# ADDENDUM #3 TO MONTANA DEPARTMENT OF TRANSPORTATION INVITATION FOR BID #HWY-309446-RP

The purpose of this addendum is for the approval of a new floor plan for only the Fergus County Bus on the 17, 20 & 21- Passenger Gas Cutaway Buses bid. The attached floor plan replaces the formerly approved floor plan in Addendum #1.

## REQUEST FOR EXCEPTIONS/APPROVED EQUALS FORM

TITLE OF DOCUMENT REFERENCE: Fergus County Floor Plan Request

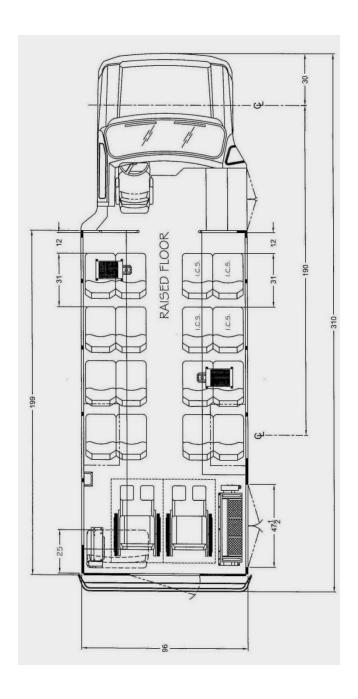
The currently approved floor plans for the 20+2 Fergus Bus do not pass the weight analysis, will you accept the following floor plan for a 16 passenger plus 2 wheelchair or 18 passenger transit style cutaway bus?

- 1. MDT ascends "Addendum #1 (1/27/10)
- 2. MDT extends the bid opening date to March 1, 2010 @ 2:00 pm.
- 3. MDT approves the requested floor plan configuration for ONLY the Fergus County bus and under these conditions:

- Vehicles must include one (1), two-passenger (double) Freedman BV Fold-A-Way Series with padded grab rails or approved equal
- Foldaway seats shall be covered in Repel, Level 6 fabric or approved equal
- Seat color the same as the stationary seats
- All foldaway seats must have either padded grab rails or a durable nylon plastic handle
- Fold away seat belts shall be USR (Under Seat Retractor)
